Product Change Notification

Addendum to PCN 518243

2156740051 Revision A

Change in plating chemistry from Bright Tin→Matte Tin

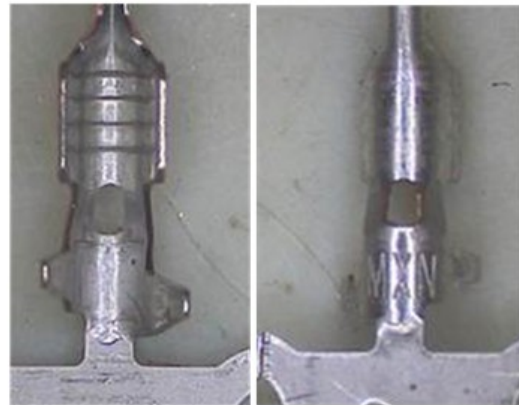
Current Bright Tin Plating Finish

Future Matte Tin Plating Finish

- Molex Lincoln Nebraska is standardizing the matte tin plating for all CP 0.64/1.5/2.8 terminals, as bright tin chemistry is being phased out of our plating operations. While this results in a change in product appearance, all form, fit, and functional performance requirements remain unchanged.

- No impact to Fit, Form or Function
- Appearance will be impacted (Bright Tin to Matte Tin)
